Panasia Sweaters Ltd

Panasia Clothing Ltd

22 October 2013

Drainage and loading on roof slab

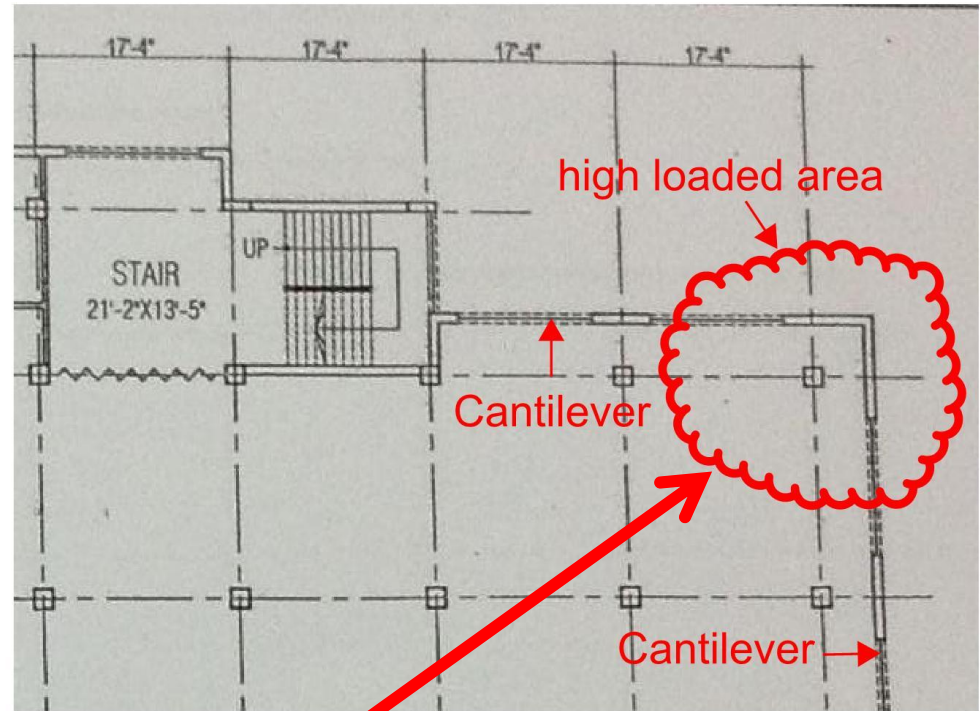
**Stub columns presumably
to accommodate new Steel
Roof to 7th Floor Level**

**17 total 2000 litre tanks
located on roof – in places
2 per span, located
midspan.**

**Lack of drainage and water
tanks loading of 7th Floor Slab**

Cantilever Slab at South-West corner of 6th Floor. Check loading

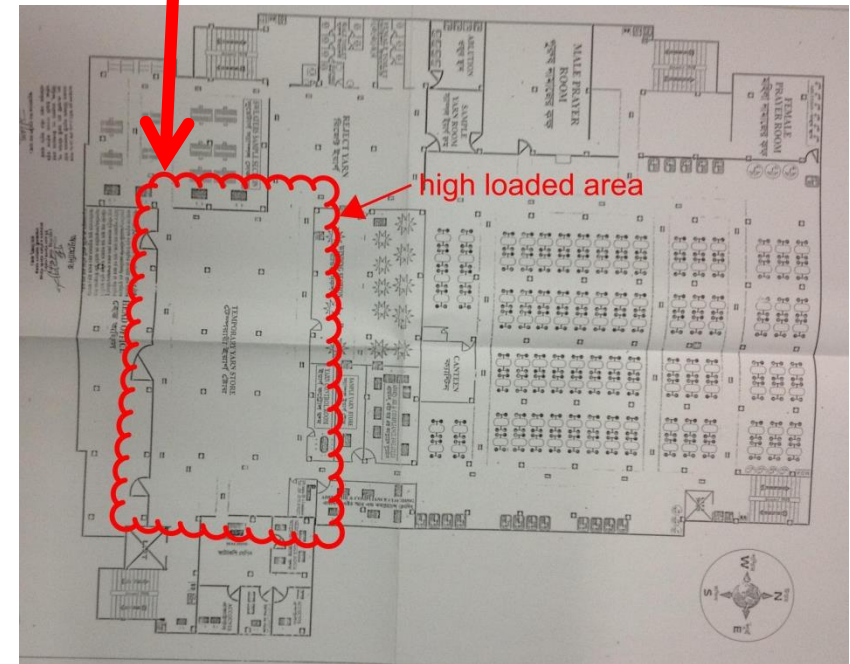
Floor Slab Cantilever subjected to heavy loading. Load needs to be limited to design load by e.g.. limiting stack height

Excessive loading in Temporary Yarn Store on 5th Floor

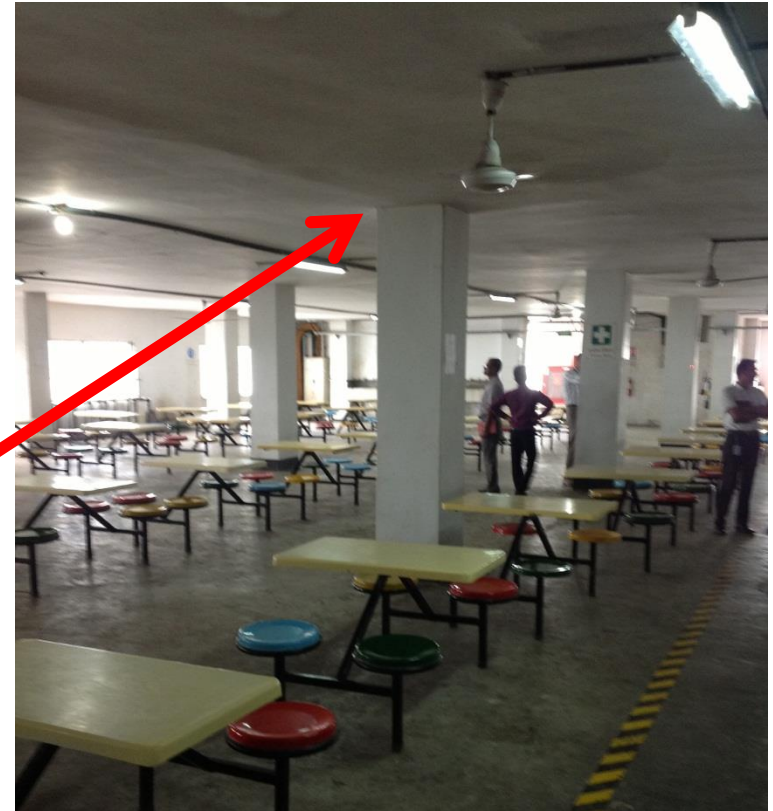
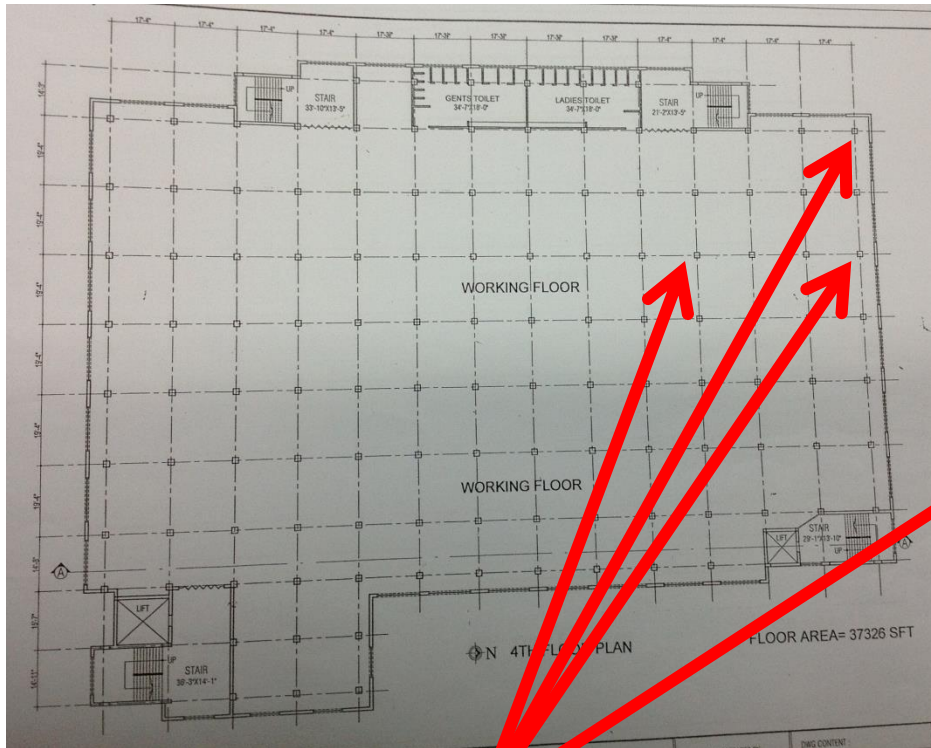
Estimated loading well in excess of documented design load of 4.25 kN/m^2 . Load needs to be limited to design load by e.g.. limiting stack height or providing 0.5m wide walkways around $1.5 \times 1.5 \text{ m}^2$ stacks

Punching Shear Stress over Columns

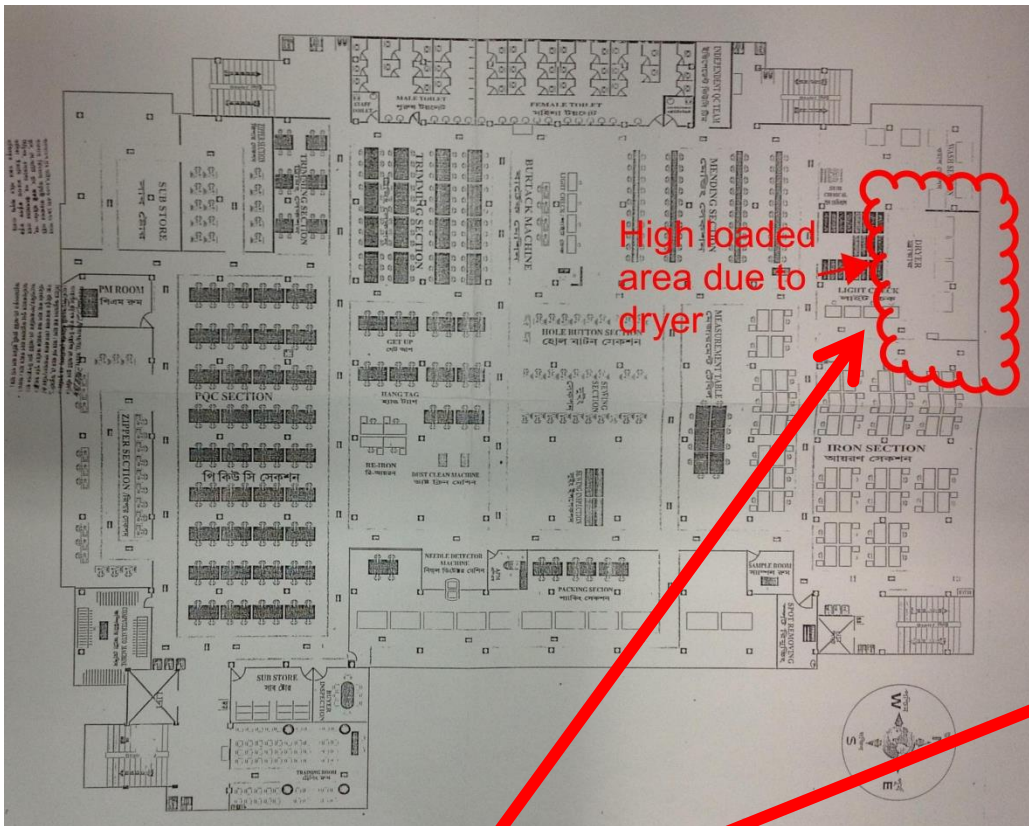
Cursory Punching shear checks done showing sufficient load carrying capacity for factory design loading as certified (4.25 kN/m^2)

Washing and Drying area at 1st Floor

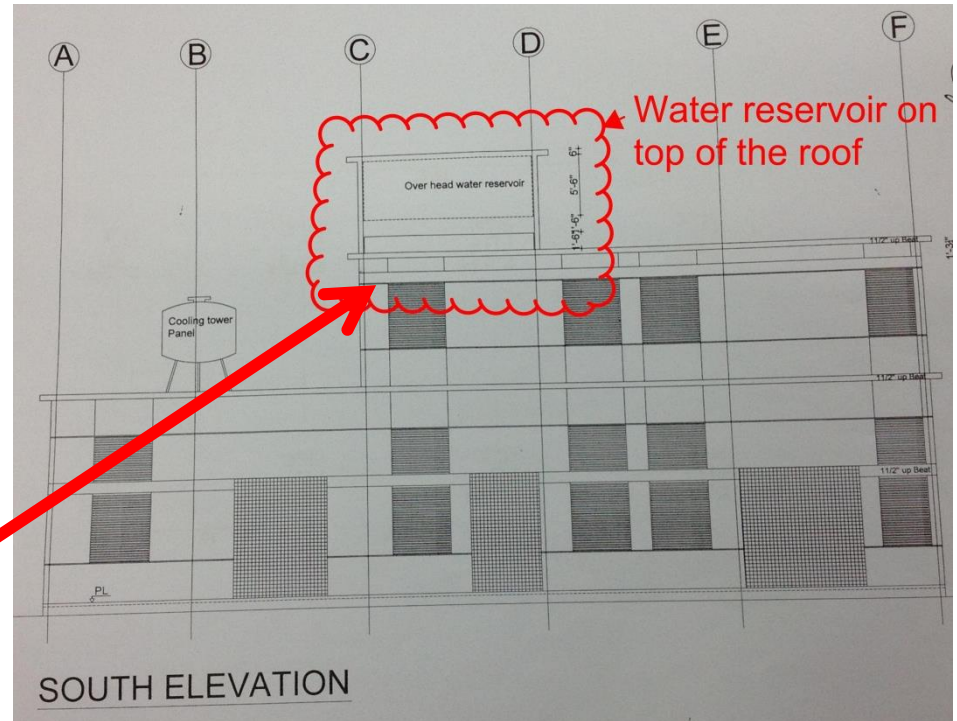
Floor Slab to be checked for additional 150mm floor build-up and Washing & Drying machine loading
